dsPIC30F5011/5013 Family Silicon Errata and Data Sheet Clarification

The dsPIC30F5011/5013 family devices that you have received conform functionally to the current Device Data Sheet (DS70116H), except for the anomalies described in this document.

Note: This document summarizes all silicon errata issues from all revisions of silicon, previous as well as current. Only the issues indicated in the last column of [Table 2](#) apply to the current silicon revision (**A4**).

FIGURE 1: dsPIC30F5011/5013 DATA EEPROM

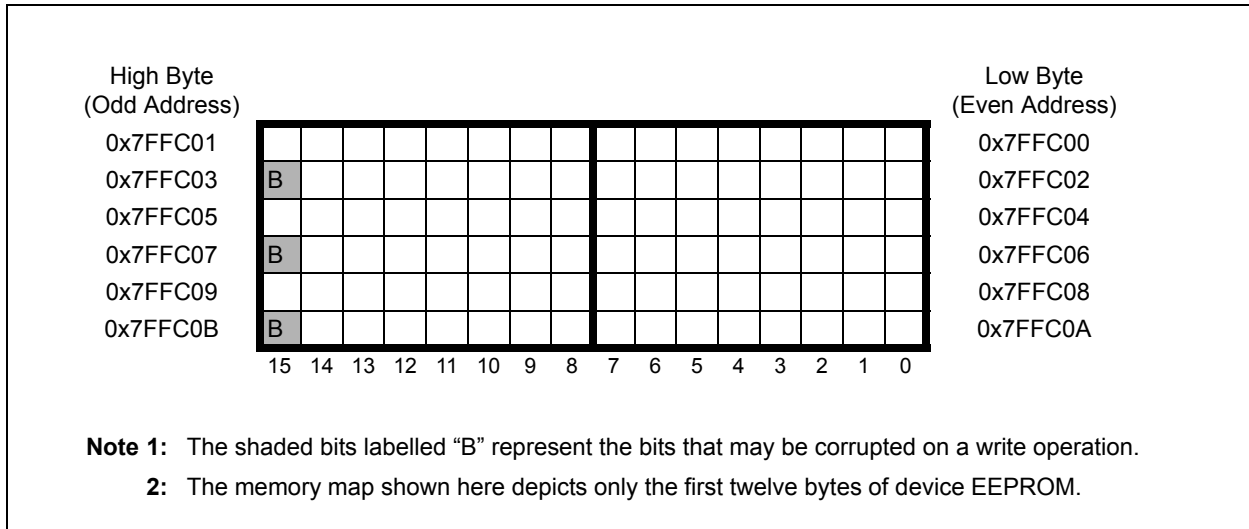
Figure 1 shows the first twelve bytes in data EEPROM and indicates the affected bits.
